Application for **SPECIAL USE PERMIT**

Property Address: 2715 Hull St. Richmond, VA, 23224 Date: 12-16-21

2715 HULL STREET RICHMOND, VA 23224 DETACHED GARAGE

2715 HULL STREET
 DETACHED GARAGE
 COVER SHEET

SP-1

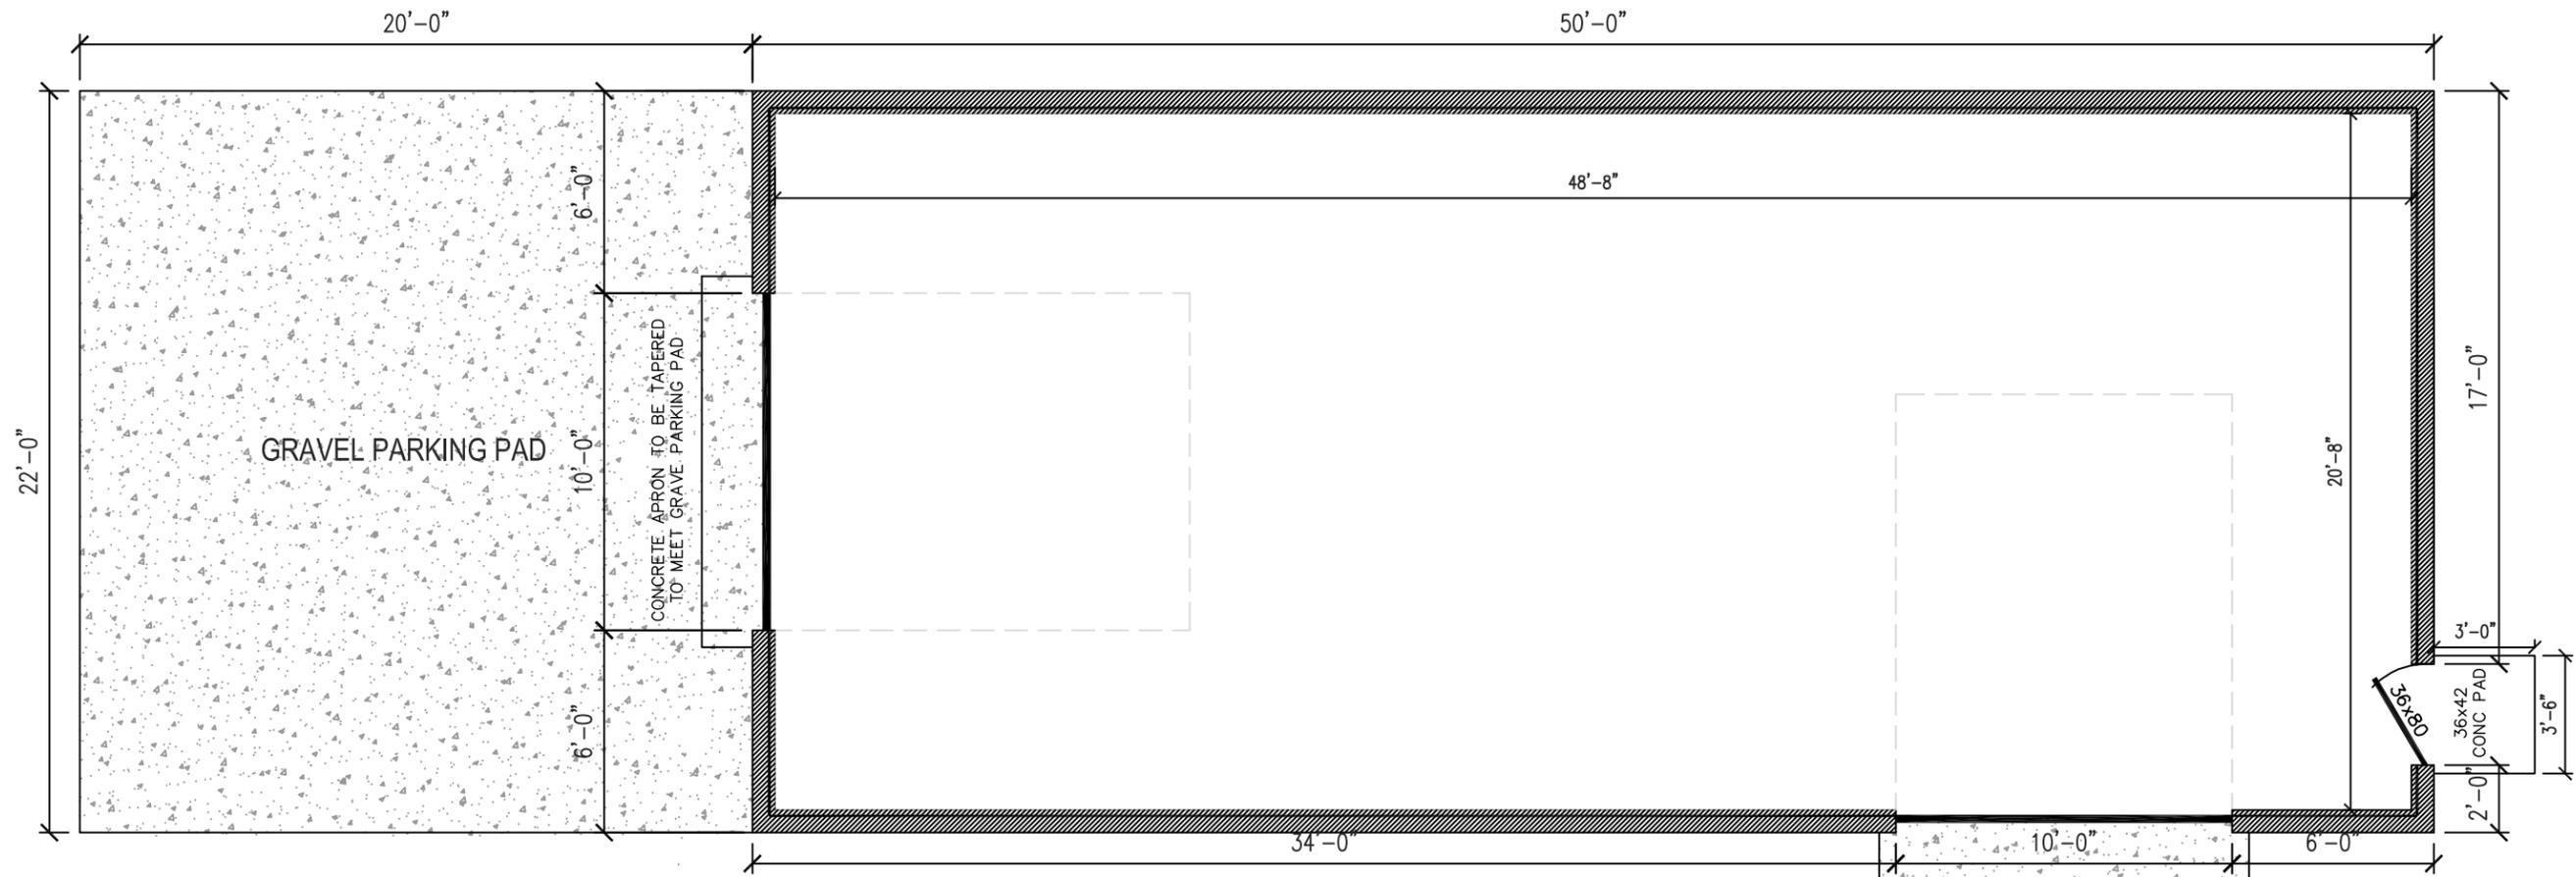
PRIOR TO APPROVING ANY BUILDING PERMITS, A PLAN MUST BE SUBMITTED SHOWING HOW THESE VEHICULAR ACCESS POINTS ARE TO BE CONSTRUCTED THAT THEY TIE IN TO THE EXISTING STREET SURFACE AND HOW STORMWATER WILL BE MANAGED? FINISHED FLOOR ELEVATION MUST BE SET TO ACCOMMODATE ANY FUTURE SIDEWALK THAT MAY BE CONSTRUCTED BY THE CITY. THIS ELEVATION SHALL BE APPROVED BY DPW PRIOR TO ISSUANCE OF ANY BUILDING PERMIT.

2715 HULL STREET
DETACHED GARAGE
FLOOR PLAN

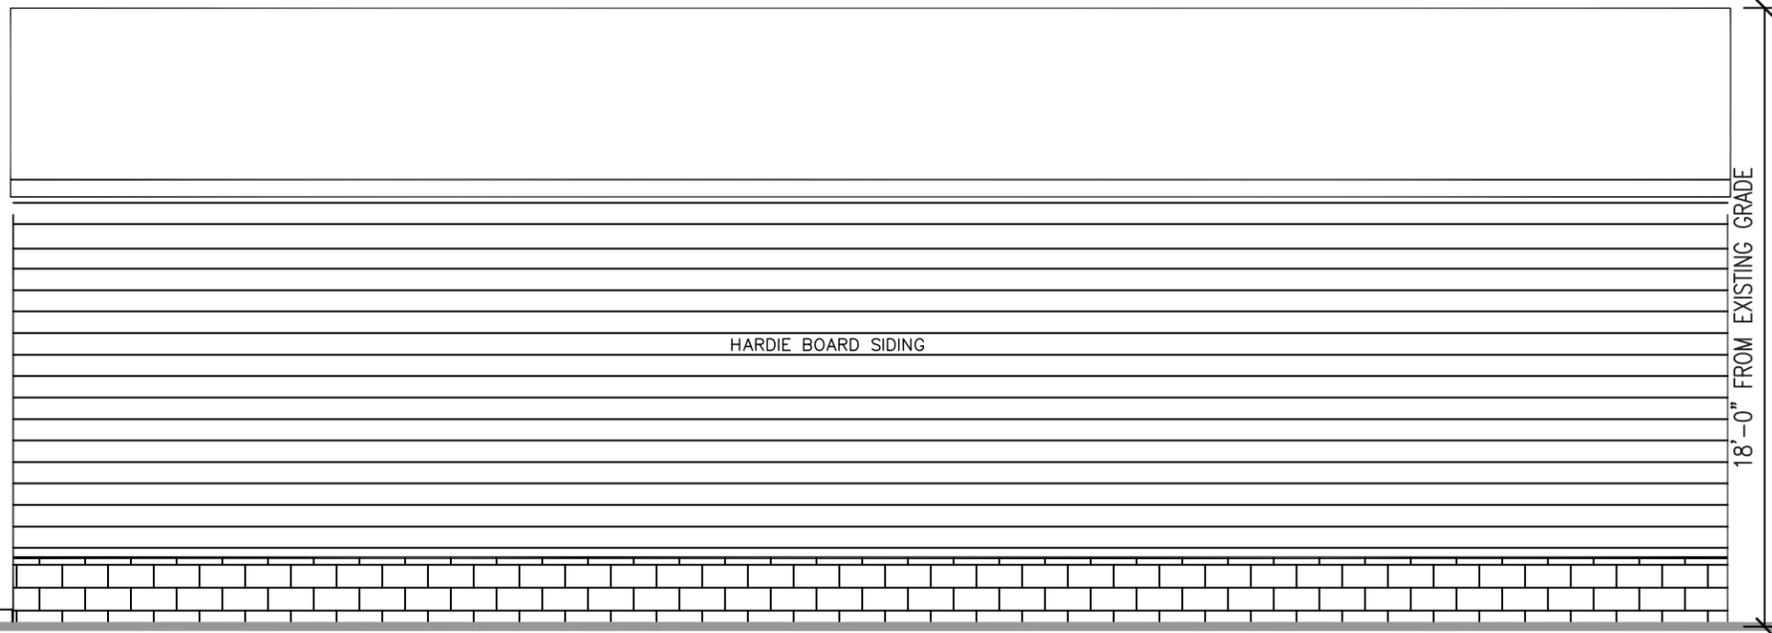
PRIOR TO APPROVING ANY BUILDING PERMITS, A PLAN MUST BE SUBMITTED SHOWING HOW THESE VEHICULAR ACCESS POINTS ARE TO BE CONSTRUCTED THAT THEY TIE IN TO THE EXISTING STREET SURFACE AND HOW STORMWATER WILL BE MANAGED? FINISHED FLOOR ELEVATION MUST BE SET TO ACCOMMODATE ANY FUTURE SIDEWALK THAT MAY BE CONSTRUCTED BY THE CITY. THIS ELEVATION SHALL BE APPROVED BY DPW PRIOR TO ISSUANCE OF ANY BUILDING PERMIT.

2715 HULL STREET
DETACHED GARAGE
DRIVEWAY ENTRANCE

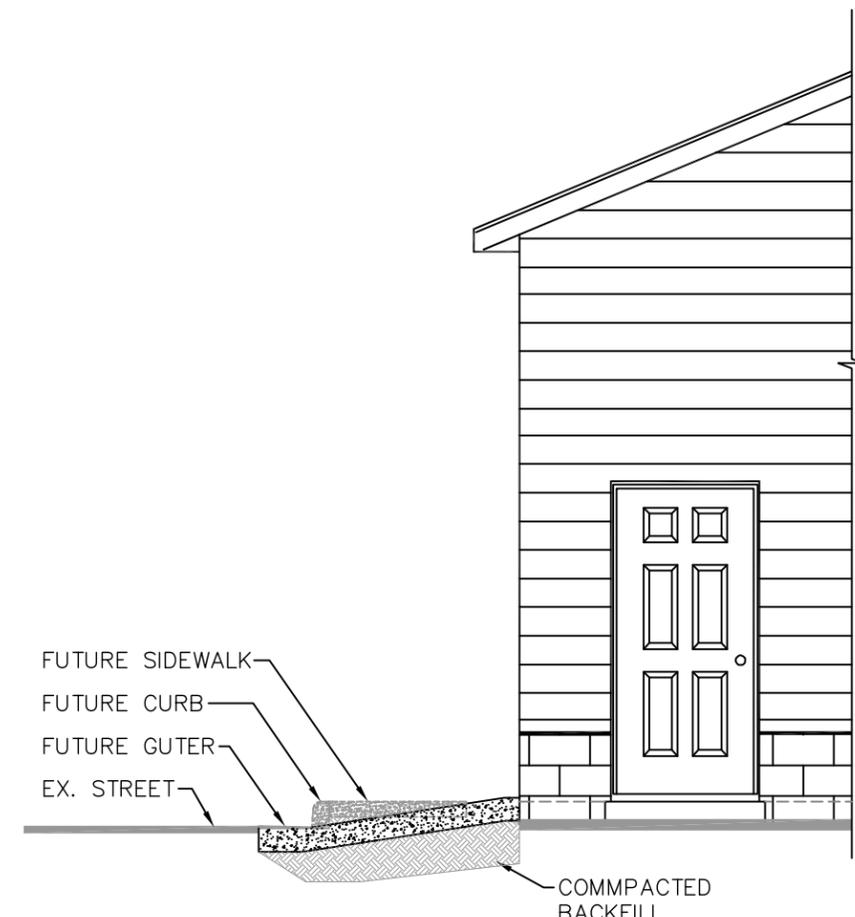
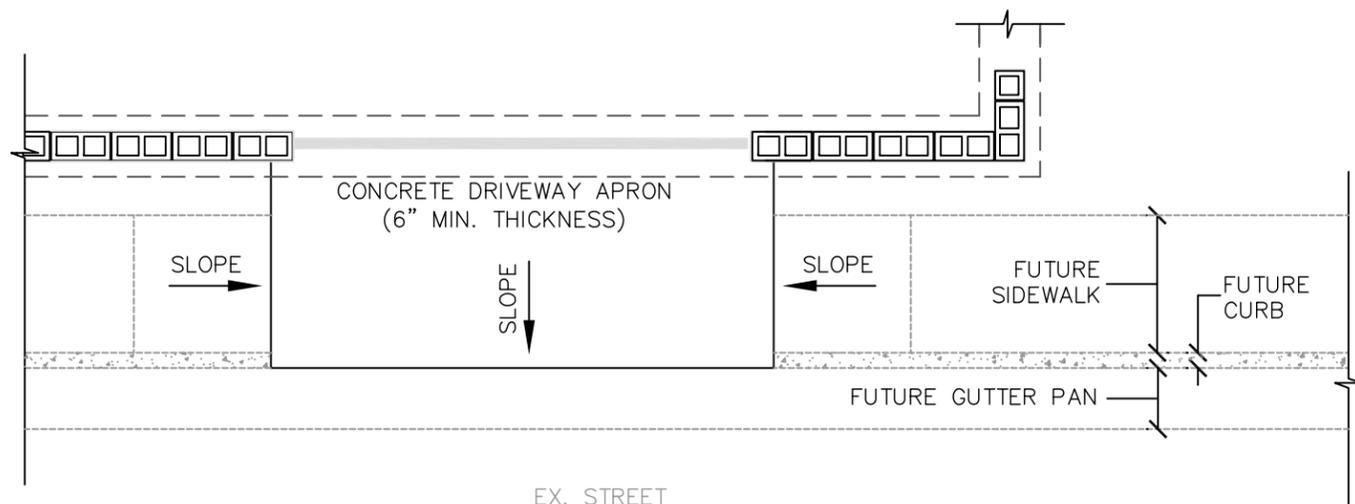
PRIOR TO APPROVING ANY BUILDING PERMITS, A PLAN MUST BE SUBMITTED SHOWING HOW THESE VEHICULAR ACCESS POINTS ARE TO BE CONSTRUCTED THAT THEY TIE IN TO THE EXISTING STREET SURFACE AND HOW STORMWATER WILL BE MANAGED? FINISHED FLOOR ELEVATION MUST BE SET TO ACCOMMODATE ANY FUTURE SIDEWALK THAT MAY BE CONSTRUCTED BY THE CITY. THIS ELEVATION SHALL BE APPROVED BY DPW PRIOR TO ISSUANCE OF ANY BUILDING PERMIT.

NOTE:
THE DIMENSIONS AND ELEVATIONS OF FUTURE SIDEWALKS, CURBS AND GUTTERS ARE UNKNOWN AND WILL BE DECIDED BY OTHER.
